Declaration of Model Addition

We (Shenzhen Golden Vision Technology Development Co., Ltd) declare that the following changes have been made to the products in Certificate 2APD7-BL6 which issued on 04/02/2020:

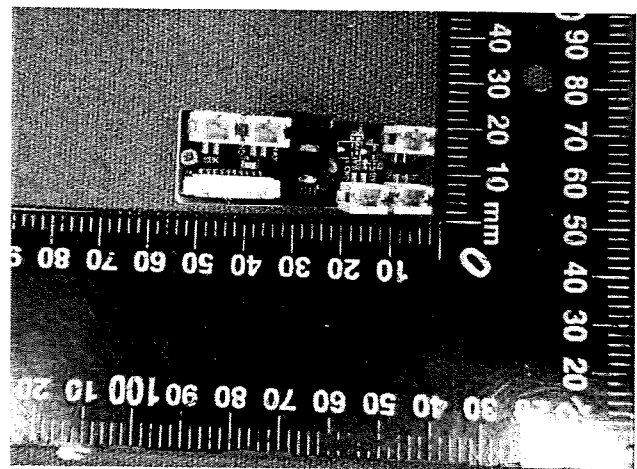
Remove the fixed holes on the small PCB (as shown in the picture below). This change does not affect RF, only need to re-test the RE of 30MHz-1Ghz.
